ORDER NO: **10-073**

PETITION FOR JOINT POLE RELOCATION

SHOWING A POLE RELOCATION

Verizon: Joint Petition with BELD – 531 Pond Street

NO. 11/10-18
DATE
10/29/2010

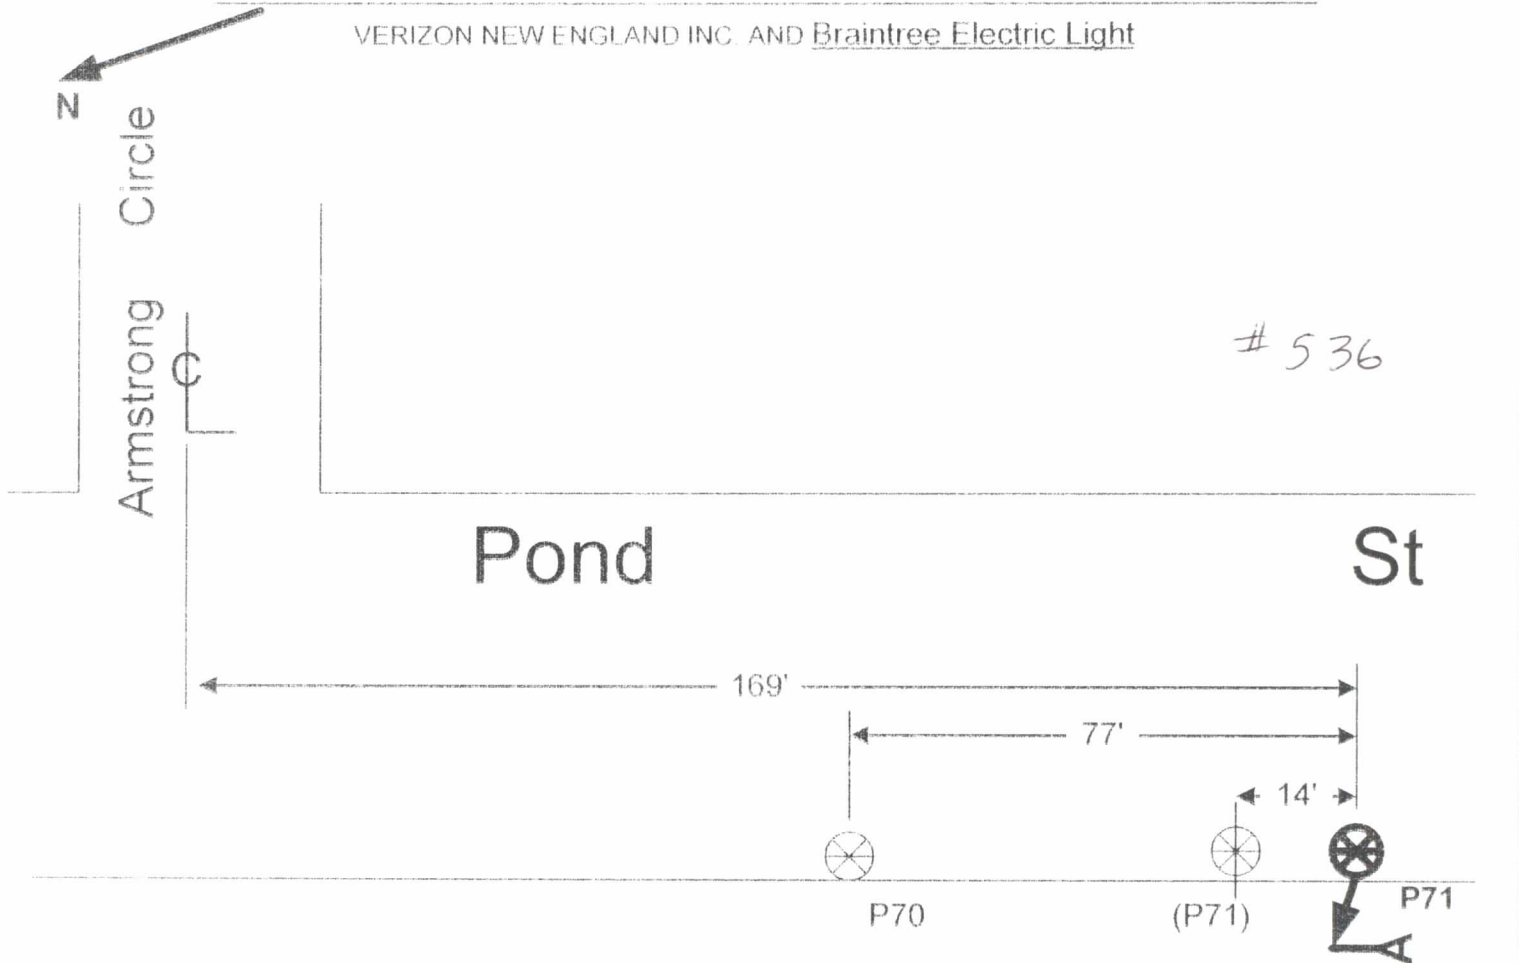
As joint owner of the utility pole in question, BELD is in agreement with and supports the proposed Verizon/BELD Petition #10-073 to relocate Pole #71 Pond St. to resolve the existing private property issue.

That section of Pond Street is slated for future sidewalk addition and may include pavement widening within the existing layout lines. Therefore, poles located in that vicinity would optimally be located so the back of the pole is 4.5 feet in from the layout line, to allow for sidewalk plowing in the future. Any “risers” should be located on the side (not rear) of the pole, and conduits should be installed with 24” minimum depth of cover. It is our recommendation that this petition **be approved**.

That section of Pond Street is slated for future sidewalk addition and may include pavement widening within the existing layout lines. Therefore, poles located in that vicinity would optimally be located so the back of the pole is 4.5 feet in from the layout line, to allow for sidewalk plowing in the future. Any "risers" should be located on the side (not rear) of the pole, and conduits should be installed with 24" minimum depth of cover.
